REMARKS

AMENDMENTS TO THE DRAWINGS:

FIG. 1
(PRIOR ART)

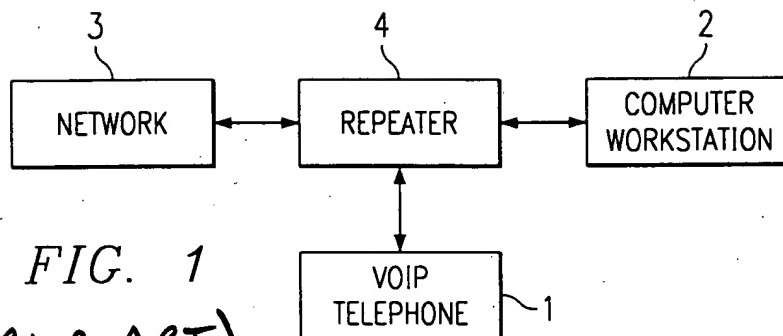
Regarding the objection to the drawings, Figure 1 has been amended to include the legend --(Prior Art)--, as kindly suggested by the Examiner. It is therefore respectfully submitted that the objection has been overcome. Wherefore reconsideration and withdrawal of this objection are respectfully requested.

In Figure 1, add the legend --(Prior Art)--, as shown in the accompanying replacement Sheet 1 of the Drawings.
